MODEL 3832EHDSC

SUBMITTAL IDENTIFICATION SHEET

WEBSTER UNIVERSITY ISB
PROJECT NAME

123553-001 REV 2
CONTRACTOR / CM SUBMITTAL NO.

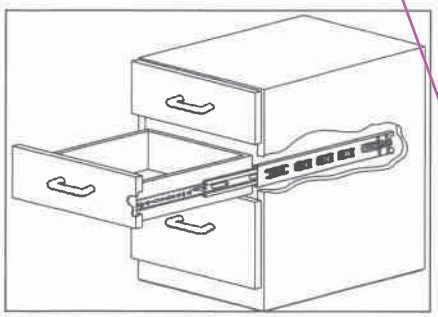
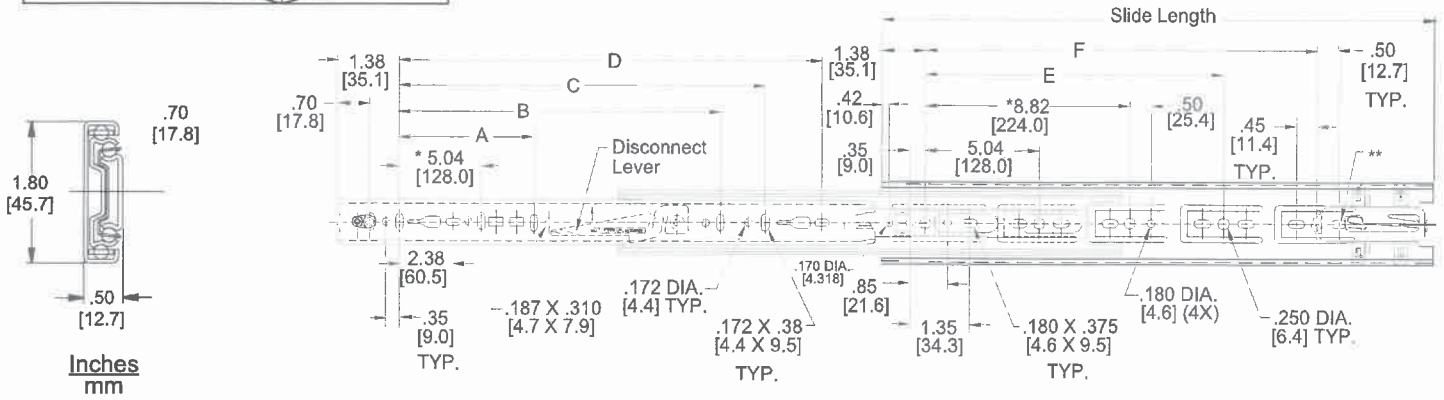
DRAWER SLIDE ADDED PER PREVIOUS MARKUP

'3832' MODEL ARE MEDIUM DUTY SLIDES WITH NO OVER-TRAVEL

PROVIDE FULL-OVERTRAVEL-EXTENSION

PROVIDE PER SPEC 123553, 2.12, E

EPOXY COATED, HEAVY-DUTY WITH OVER-TRAVEL-EXTENSION
